WITTENBORG

TECHNICAL INFORMATION

TYPE NO	TYPE	T.INO
FB/IN/ES 5100	FB/IN/ES	07/01
SERIAL NUMBERS AFFECTED From	machine number 502922	SUED BY Documentation / Wittenborg Odense
SUBJECT RS 232 data connector		SUED FOR (X): ction formation x

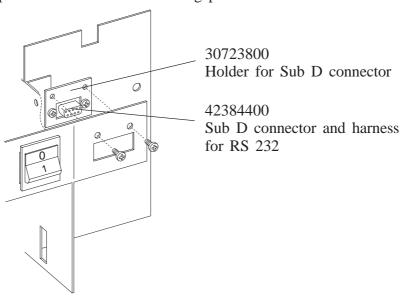
- From the above mentioned machine number an RS 232 data connector has been mounted in the electronic box. The following pages show the update of the wiring diagrams.
- To update machines produced earlier than machines from the above mentioned machine number, it will be possible to order the following parts:

• Fit the items as shown on the illustration.
